Generic Environmental Impact Statement
for License Renewal of Nuclear Plants

Final Report

U.S. Nuclear Regulatory Commission

This addendum to NUREG-1437, *Generic Environmental Impact Statement for License Renewal of Nuclear Plants*, documents the staff's analysis of the potential cumulative impacts of transporting spent nuclear fuel in the vicinity of a single high-level waste repository, and summarizes the staff's analyses undertaken to determine whether the environmental impacts of the transportation of higher enrichment and higher burnup spent nuclear fuel are consistent with the values of 10 CFR 51.52, Table S-4. The intent of the study is a generic analysis of the cumulative impacts associated with transportation of spent nuclear fuel as a result of nuclear power plant license renewal. The results of the analysis will be used to amend 10 CFR Part 51.53 and Appendix B to Subpart A of 10 CFR Part 51, and is not intended to support any other regulatory decision by the NRC. This addendum also includes an appendix that summarizes comments on the draft of the addendum, and documents the staff's responses to those comments.

Figure A.2. Routes analyzed in this study. 1 = from the northeast through downtown (I-15 to 95), 2 = from south through downtown (I-15 to 95), 3 = from the northeast using the Beltway (I-15 to I-215 to 95), 4 = from the south using the Beltway (I-15 to I-215 to 95).

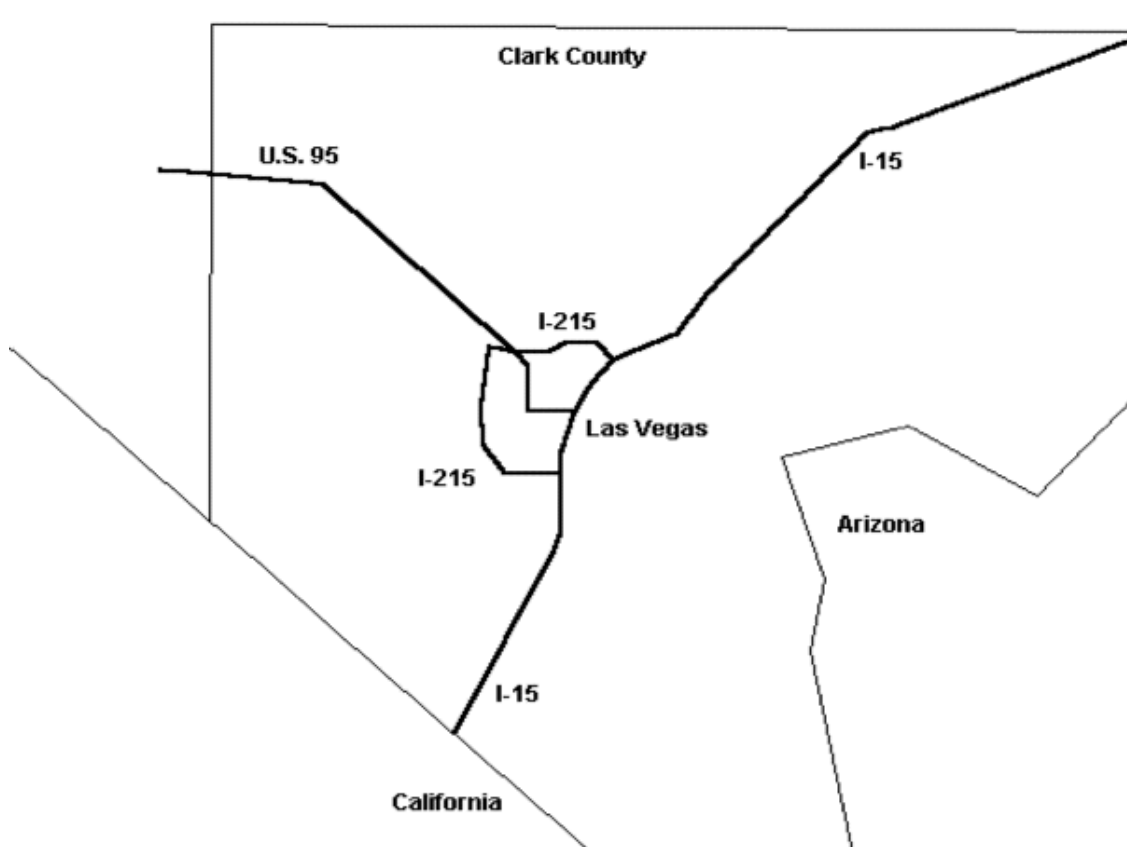
Comment: Addendum 1 assumes that truck transport would have the highest doses. This assumption is not necessarily valid. Also, a different route that avoids Las Vegas should be addressed. (A route through Nellis Air Force Base and down US-95 is being considered by DOE and it has been shown to have higher risks of accident fatalities and to increase the radiological risk.) Routes chosen in Addendum 1 do not bound the analysis properly.

Comment: The study area is inaccurately defined and the location of some cities is incorrectly stated.

Response: The transportation and route scenarios and their underlying assumptions were designed to reflect situations that most likely would result in highest doses in order to bound the analysis properly as the routes chosen for this analysis were the most populated routes in the state of Nevada. Also, as noted in an earlier response, the NRC staff consulted DOE in determining that truck shipments through densely populated areas of Clark County, Nevada, would have the highest potential impacts among the alternative transportation scenarios that would be given serious consideration in decisions relating to the suitability of the site undergoing study for a repository at Yucca Mountain.

The comment that a route from Nellis Air Force Base down US-95 is higher risk than those selected by the NRC staff provided no specific details concerning that assertion. In the NRC staff's view, any route that bypasses major centers of population will have significantly lower radiological impacts. With regard to traffic accident rates, while it may be true that certain routes will have accident rates that are higher than average, the average rates are low enough that modest increases from the average will not significantly change the staff's conclusions.

Response: During the preparation of Addendum 1, the initial study area selected for analysis emphasized the urban areas in and near Las Vegas. Route selections were based in part on their proximity to those areas, not to county borders. However, in response to public comments, the study area was expanded to include the entire county. Consequently, the "entry" point for SNF shipments shifted to cities such as Mesquite.
